ADM48-25 Part II

IBC: 1705.21 (New), TABLE 1705.21 (New)

Proponents: Theresa Weston, The Holt Weston Consultancy, representing Air Barrier Association of America (ABAA) (holtweston88@gmail.com)

FIGURE R602.3(1) TYPICAL WALL, FLOOR AND ROOF FRAMING

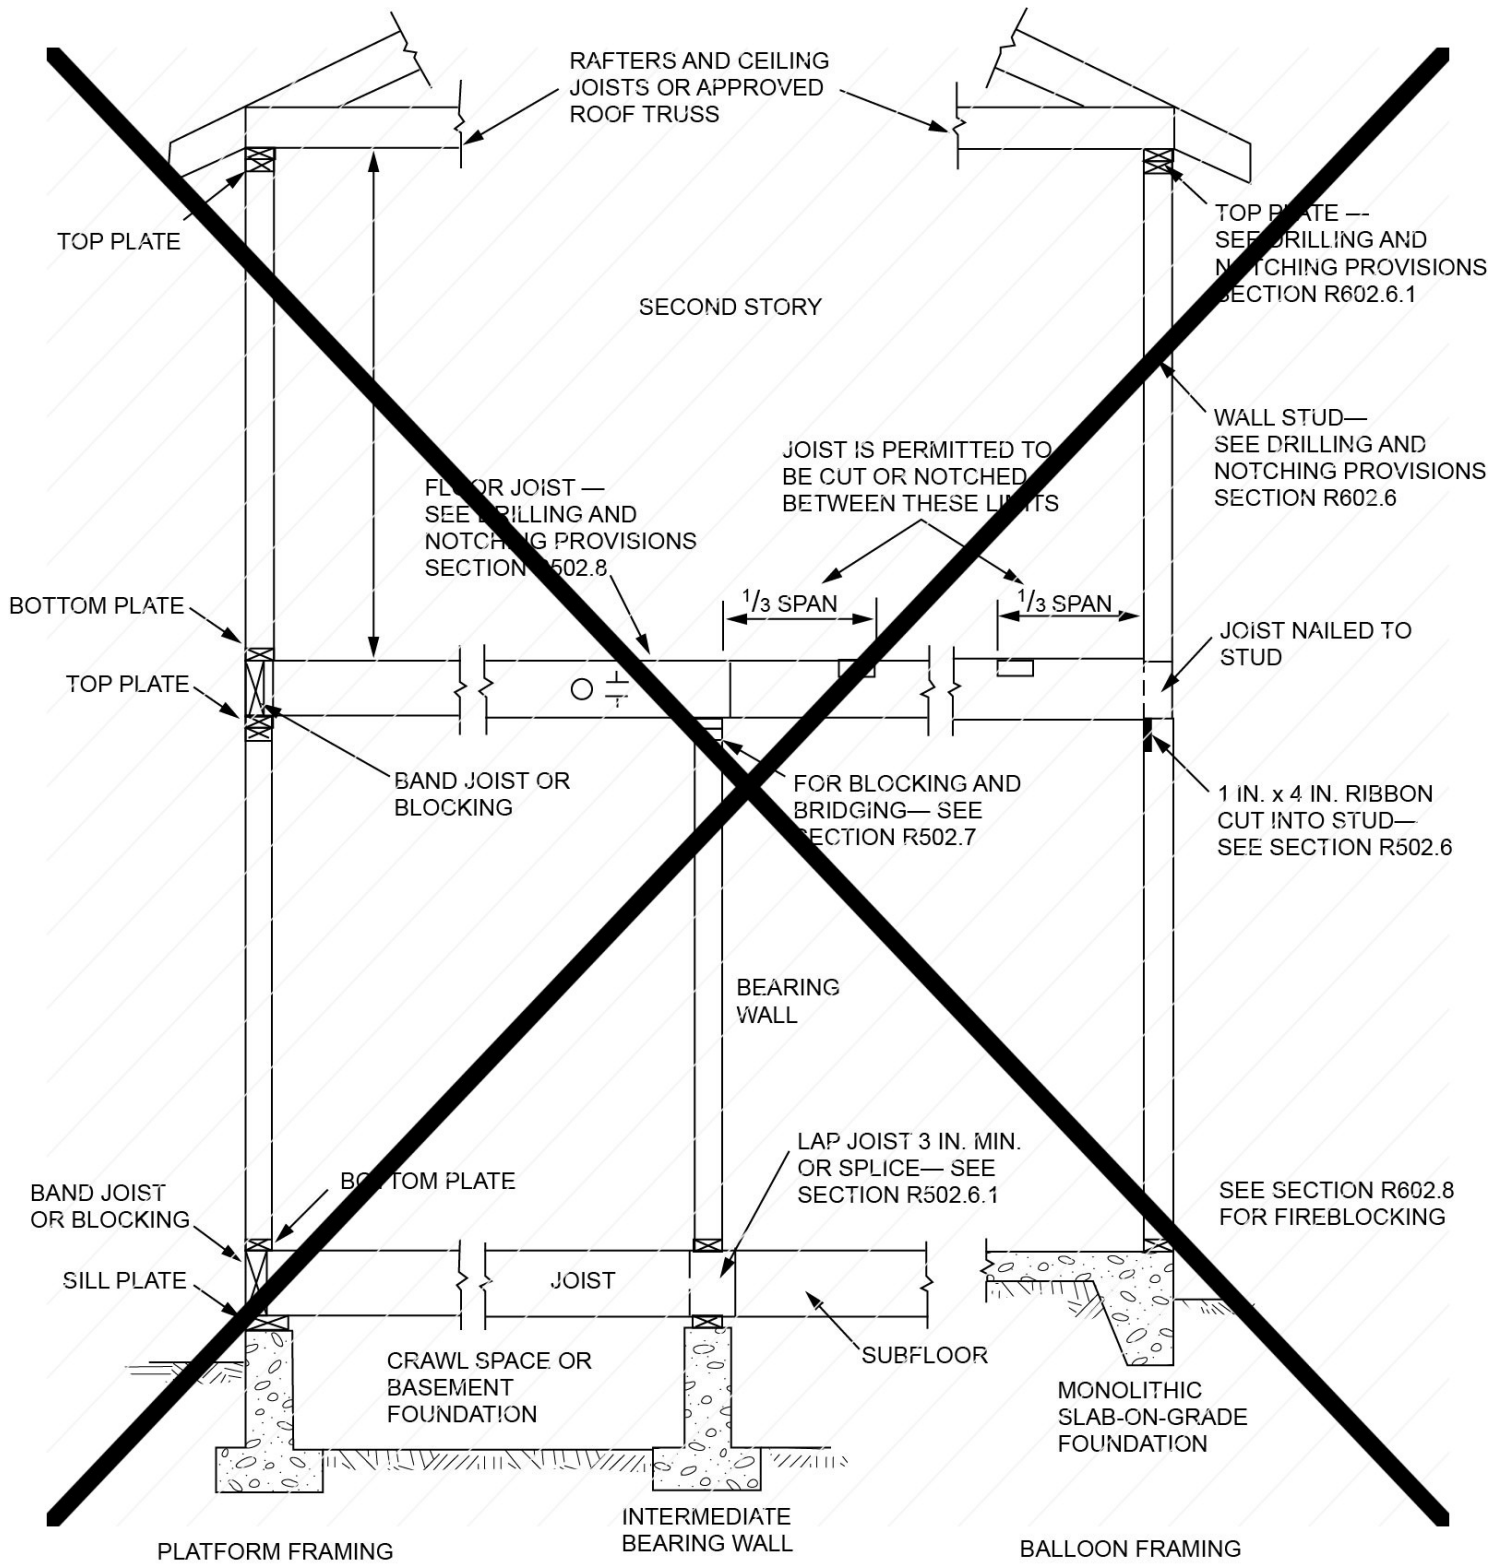
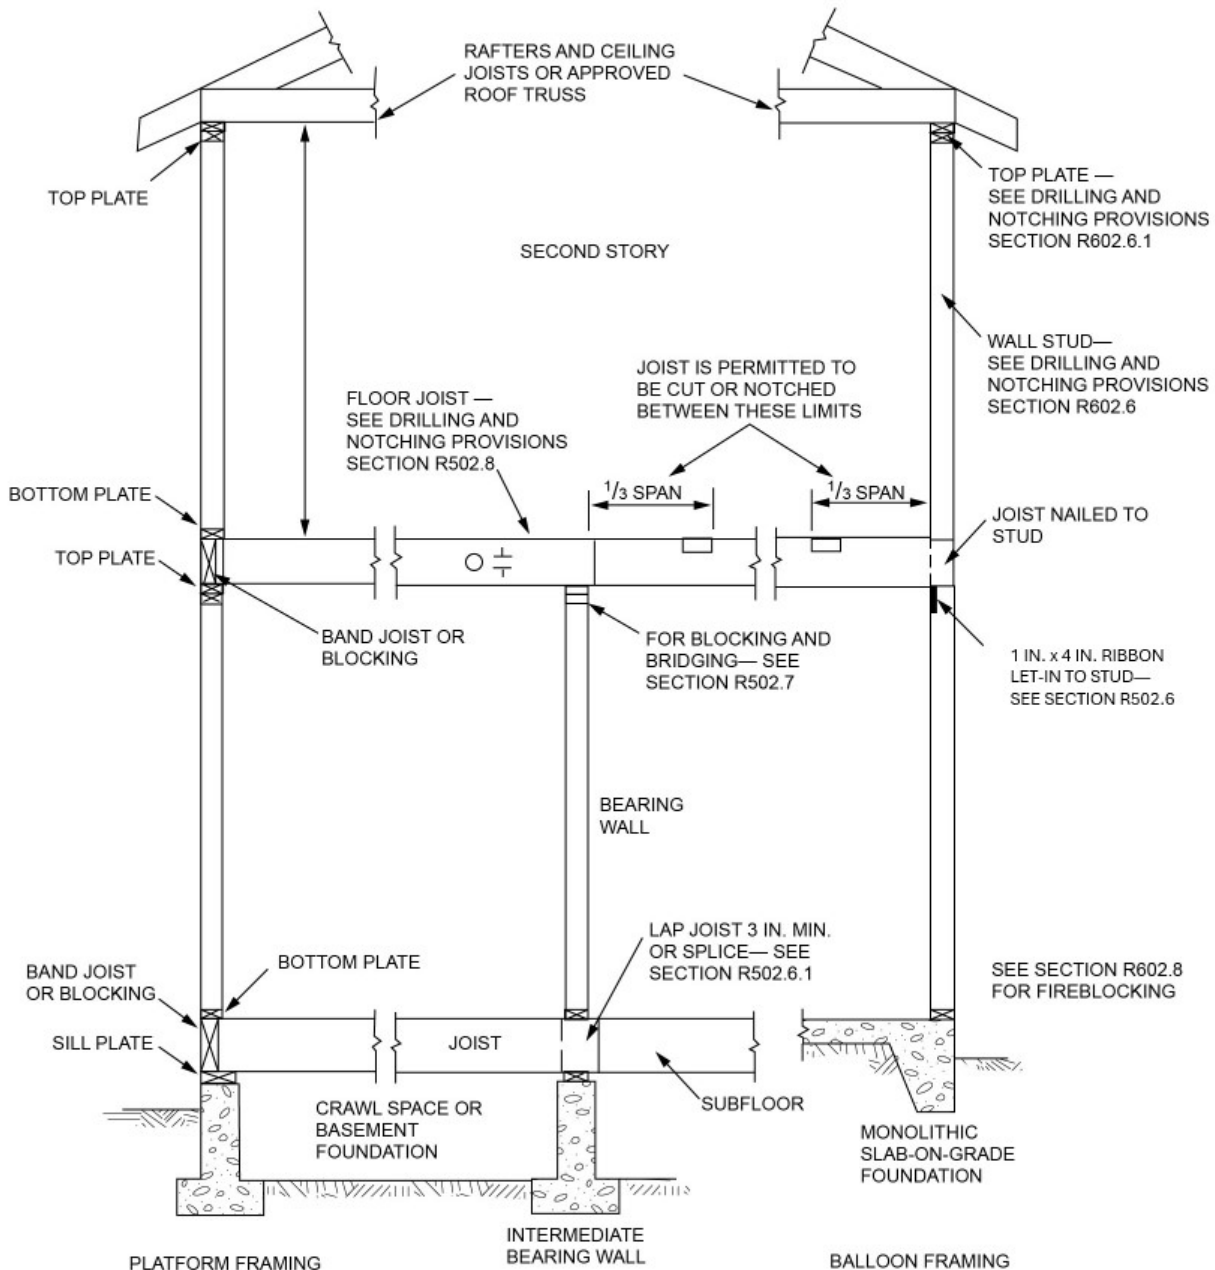
Reason: Section R502.6 permits a ribbon strip to provide bearing for joists but does not specify how the ribbon strip is required to be let-in to the stud and fastened.

Additionally, the joists are required to be nailed to the adjacent stud, but no fasteners are specified. This code change provides provisions for proper installation of the ribbon strip and associated fastening with two new rows being added to Table R602.3(1). The nailing for "Ribbon strip to supporting joists" is based on current item #20 and the nailing for "Joist to stud where supported by ribbon strip" is based on current item #22. Additionally, the ribbon strip callout in Figure R602.3(1) has been revised from "cut-in" to "let-in" to be consistent with the common terminology used in the code.

FIGURE R507.9.1.3(1) R507.8.3(1) PLACEMENT OF LAG SCREWS AND BOLTS IN LEDGERS

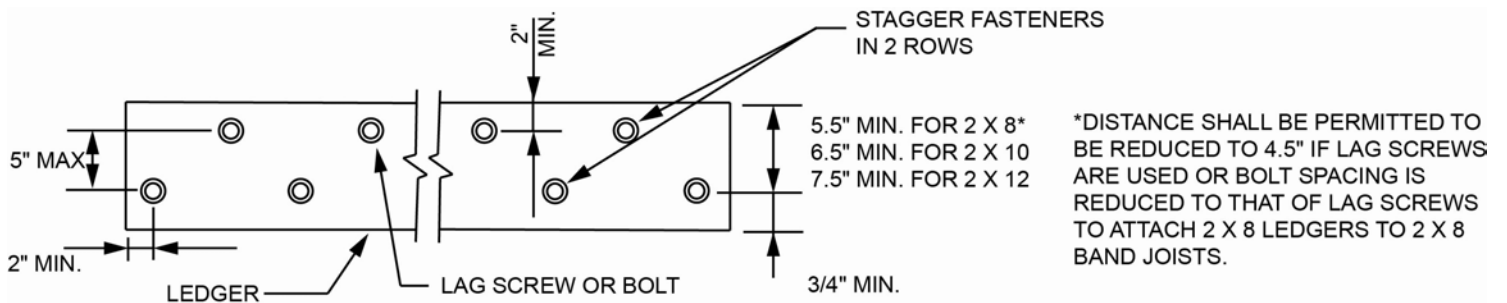
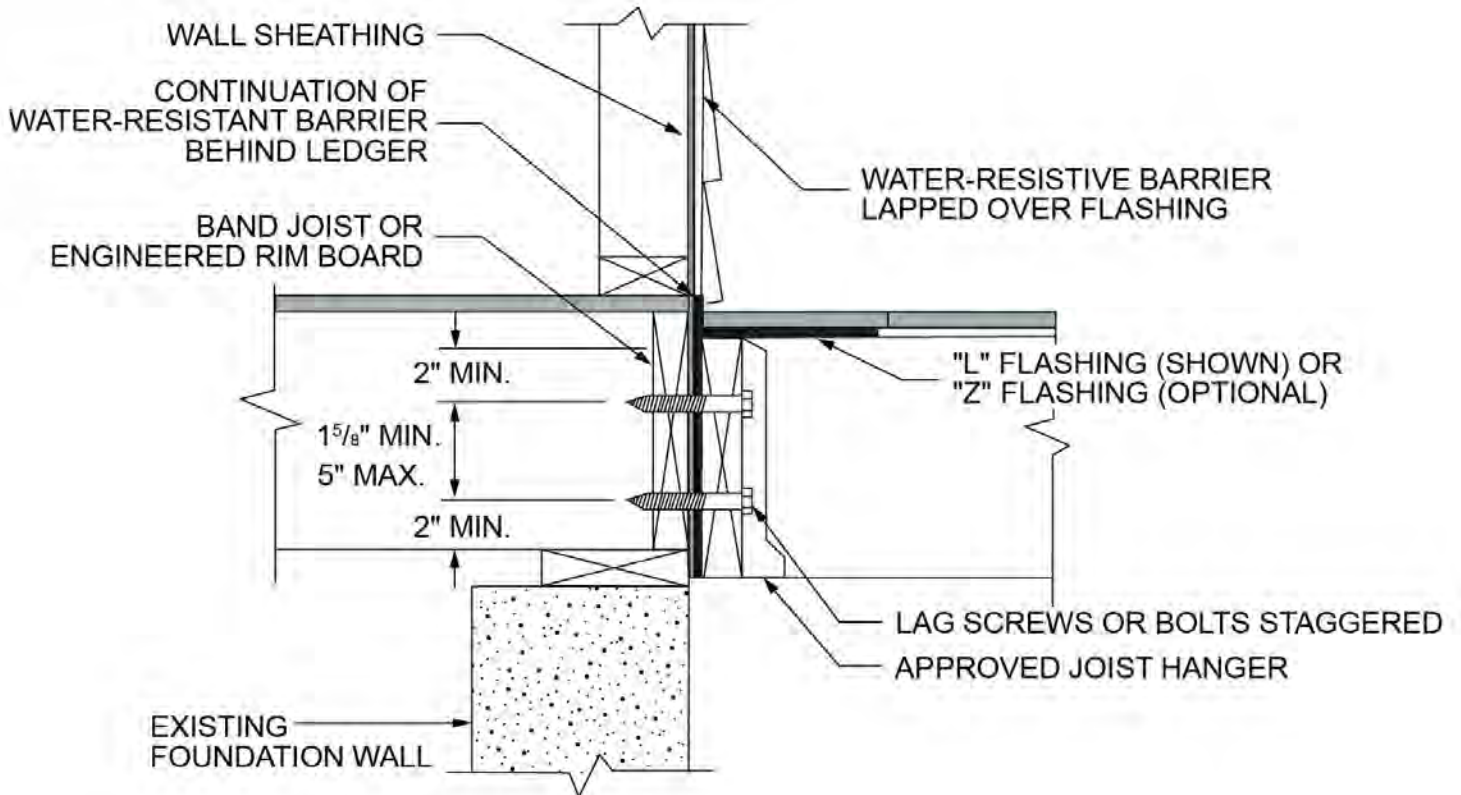
Reason: Section R703.4 "Flashing" was changed in the 2024 IRC to reference deck ledger flashing to the new Section R507.9.1.5. This proposal simply bypasses that double reference. I suggest deleting the statement about ledger flashing performance (not let water contact the band joist), as this footnote is just meant as a reminder that there are additional ledger flashing codes. The ledger flashing codes referenced in this footnote provide sufficient detail for ledger flashing performance.

FIGURE R507.9.2(1) R507.9(1) DECK ATTACHMENT FOR LATERAL LOADS

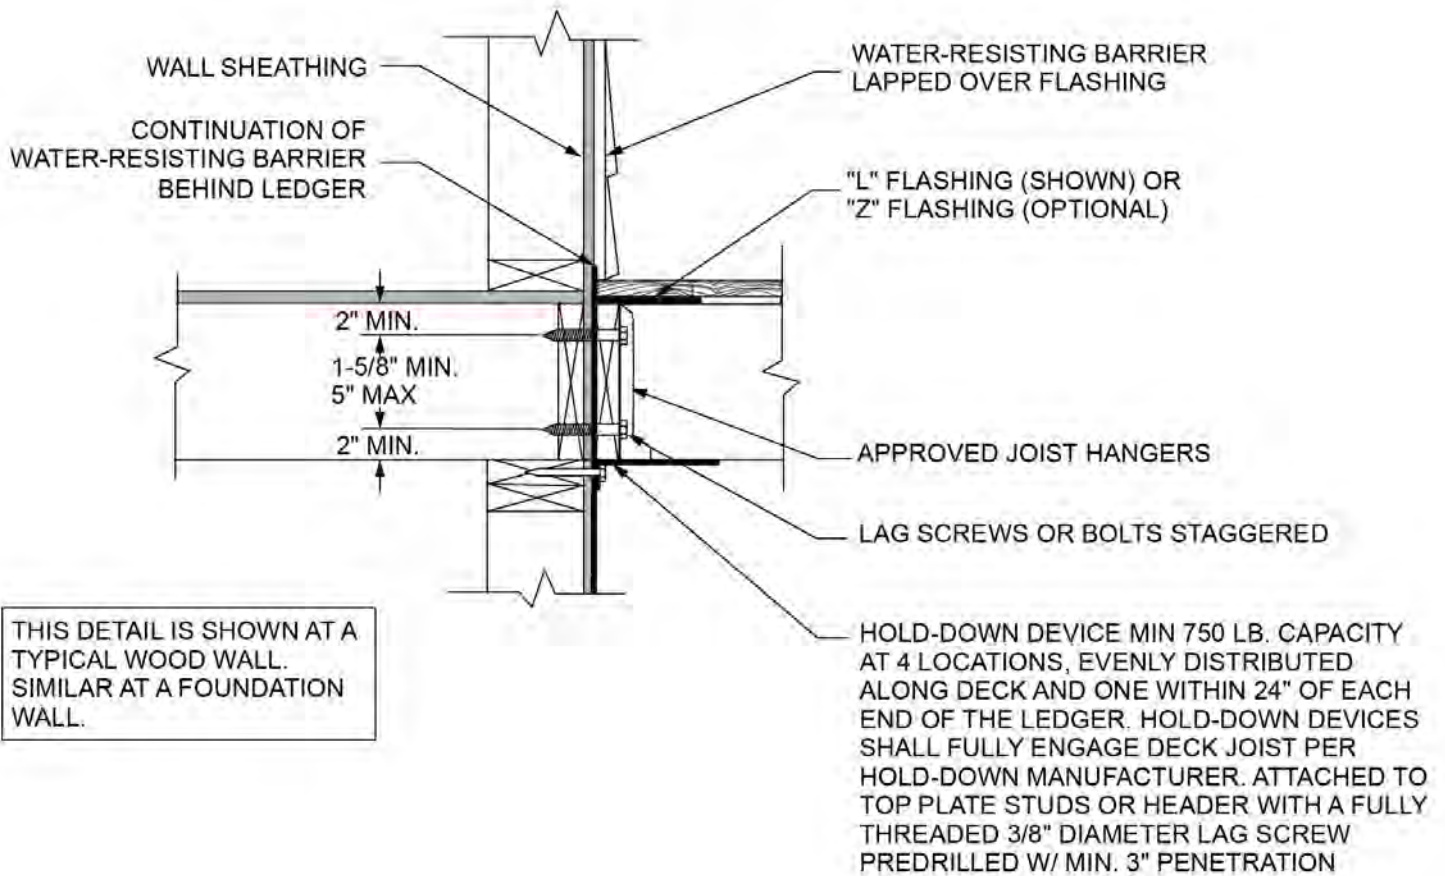
R507.9.2 R507.9 Lateral connection bracing. Lateral loads shall be transferred to the ground or to a structure capable of transmitting them to the ground. Where ~~the lateral bracing is provided with a load connection is provided~~ in accordance with Figure R507.9-2(1), hold-down tension devices shall be installed in not less than two locations per deck, within 24 inches (610 mm) of each end of the deck. Each device shall have an allowable stress design capacity of not less than 1,500 pounds (6672 N). Where the lateral load connections are provided in accordance with Figure R507.9-2(2), the hold-down tension devices shall be installed in not less than four locations per deck, and each device shall have an allowable stress design capacity of not less than 750 pounds (3336 N).

FIGURE BE101.1 EPA MAP OF RADON ZONES

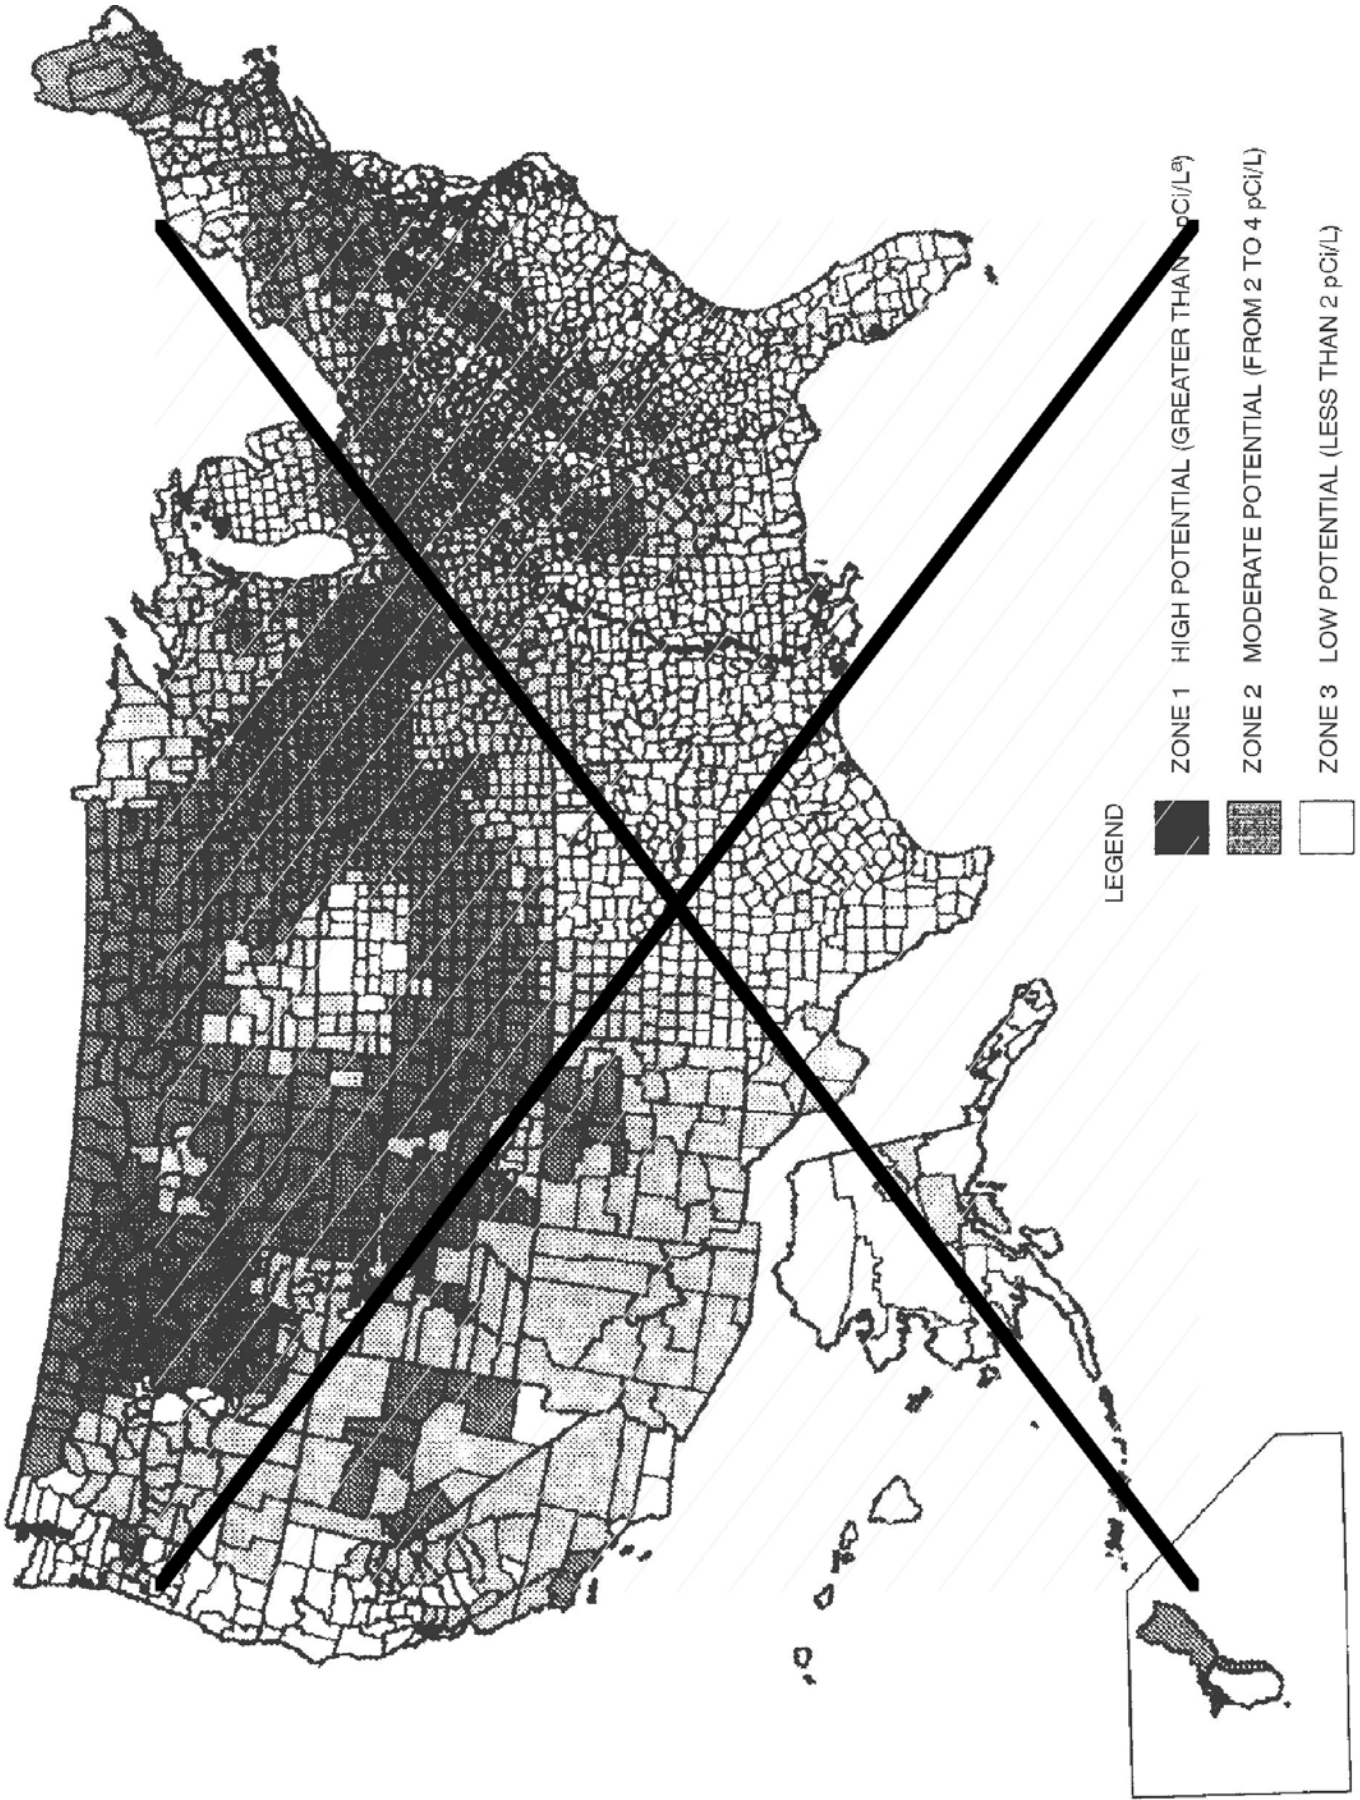
BE101.1 General. This appendix contains requirements for new construction in jurisdictions where radon-resistant construction is required. ~~Inclusion of this appendix by jurisdictions shall be determined through the use of locally available data or determination of Zone 1 designation in Figure AF101.1 and Table AF101.1.~~
